Bulletin No: T-1022

TECHNICAL SERVICE BULLETIN

Main Generator Wires can possibly chafe through the wire insulation & Control box edging, resulting in a potentially hazardous and damaging short to the generator body.

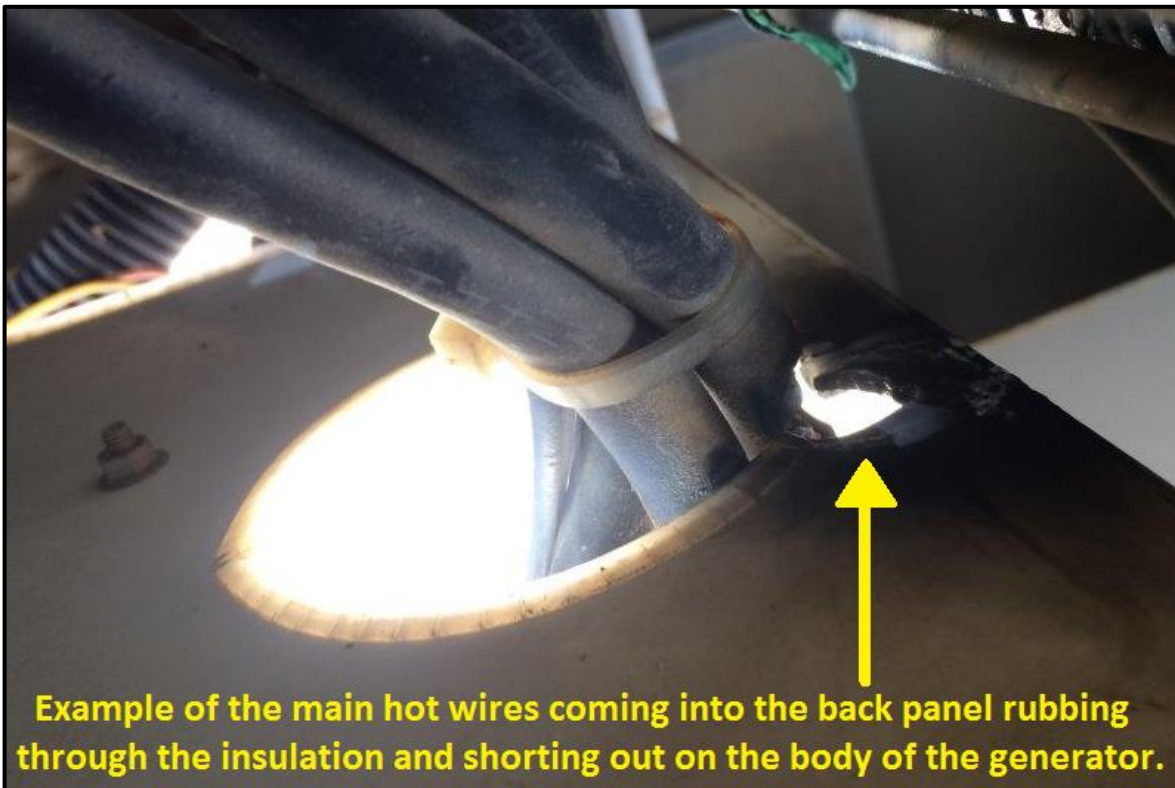
We have experienced an issue on Multiquip generators that requires your immediate attention! We have documented several incidents where the Main Generator Wiring can possibly chafe through the wire insulation & Control Box Edging Part# 0330000210, resulting in a potentially hazardous and damaging short to the generator body. Please thoroughly inspect all of your Multiquip Generators for evidence of this potential issue. So far this issue has been isolated to only the DCA125SSIU & DCA150SSIU models but we suspect it may affect other models also.
